Referee #1 (Main)

Brief Communication: GIS-based liquefaction evaluation and risk assessment of facilities in Kimhae City, South Korea

Figure 8. Bridges superimposed on spatial distribution of LPI for $M_w = 5.0$ and 6.5 earthquakes

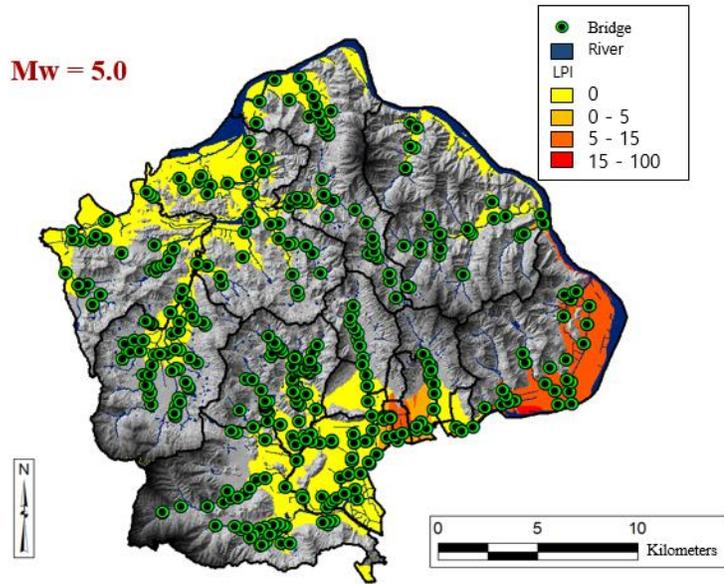
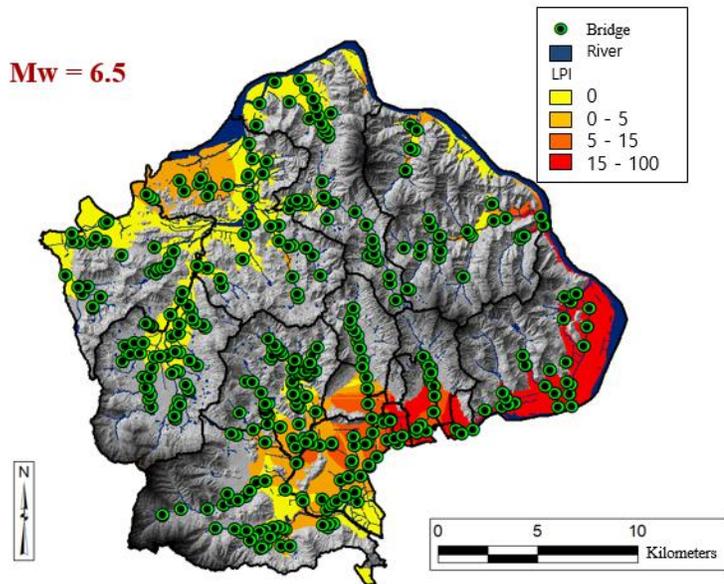
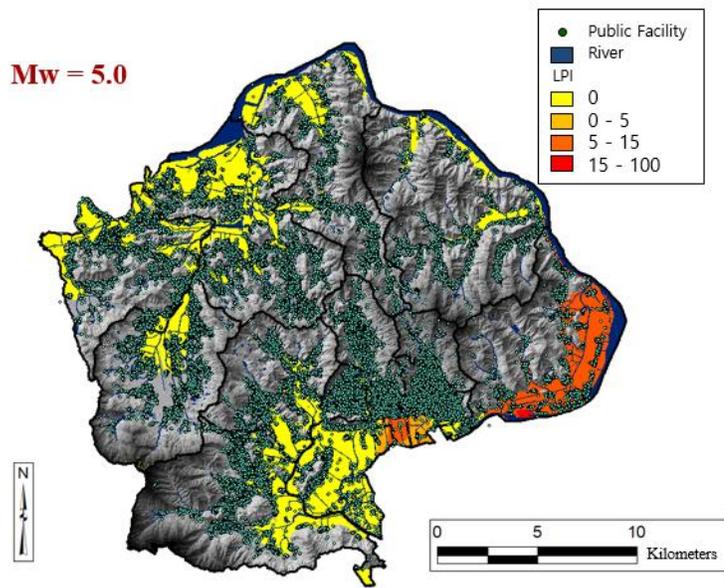
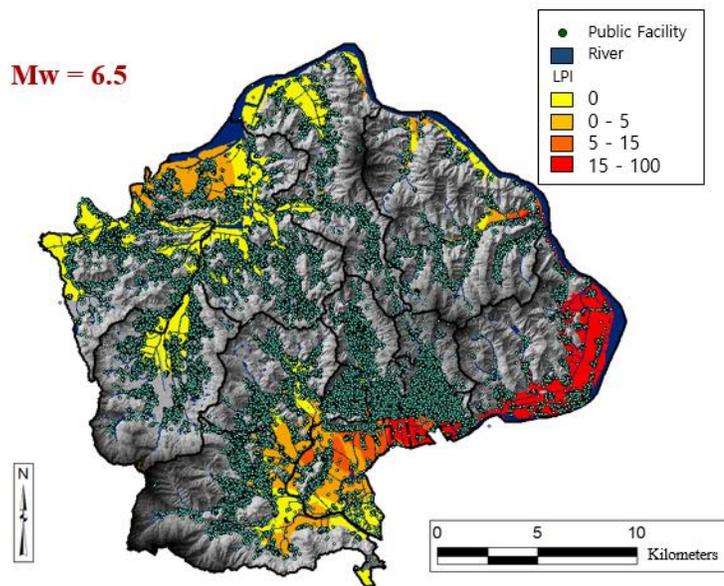
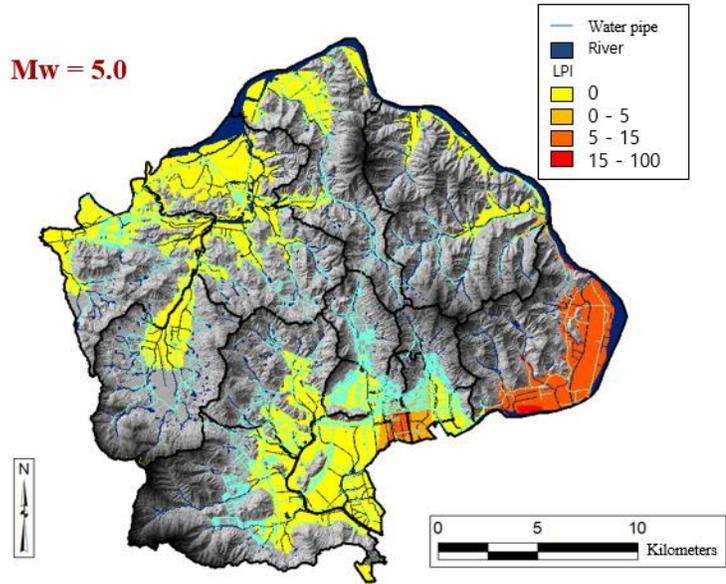
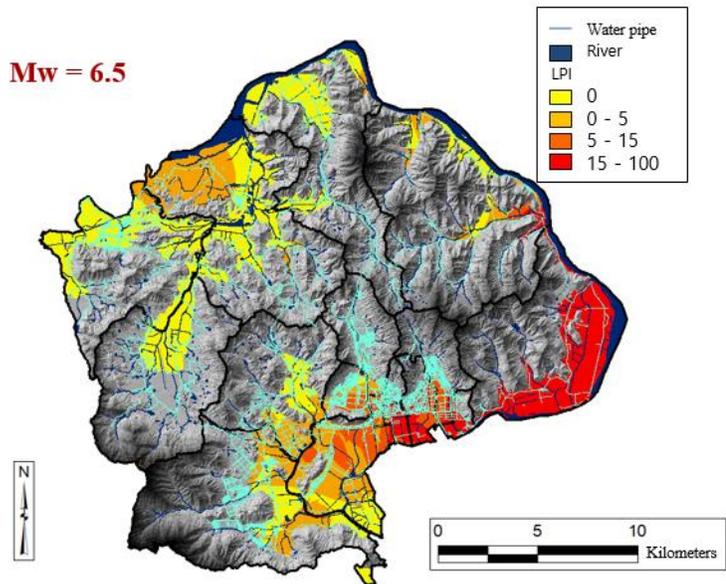
Referee's comments	Revised contents
Figures 6 are too small and the facilities are unreadable in many cases. Please, revise.	Figures 8-10 are enlarged and modified with high resolution.
